The Natasha Project- Proposed New Residential Construction Project (DPD #3017563)

Presentation Package

Design Review Recommendation Meeting - DPD #3017563

21 April 2015

2- Canopy Section

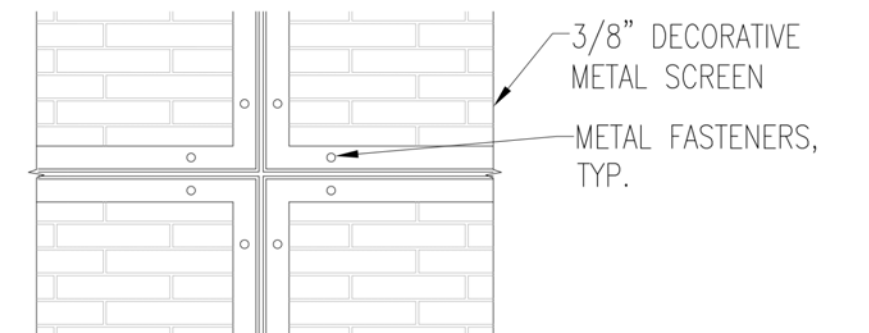
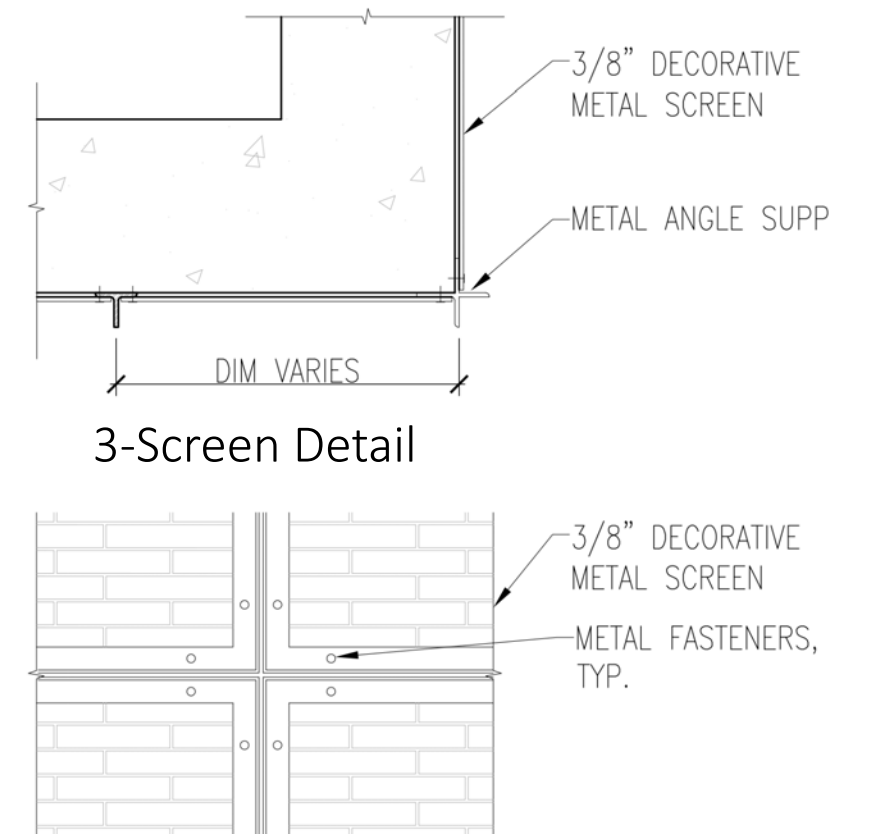
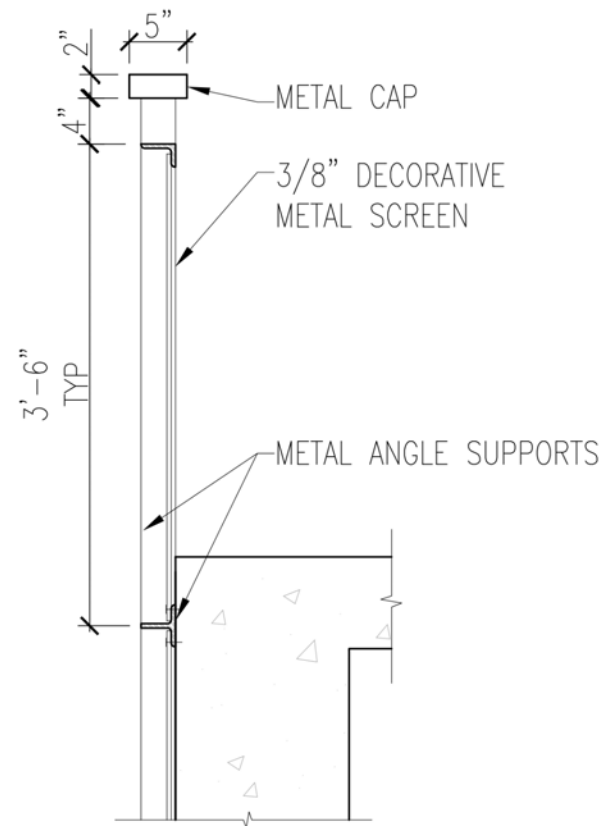
g. Provide details of the overhead canopy including materials, thickness and detailing. (C4.1)

h. Consider a solid material for the soffit along Western Ave. (C4.1)

c. Provide details of the overhead canopy including materials, thickness and detailing.

Details provided on Sheet 32.

Tongue-and-groove cedar soffit is proposed and detailed on Sheet 32

Refer to Sheet 32.
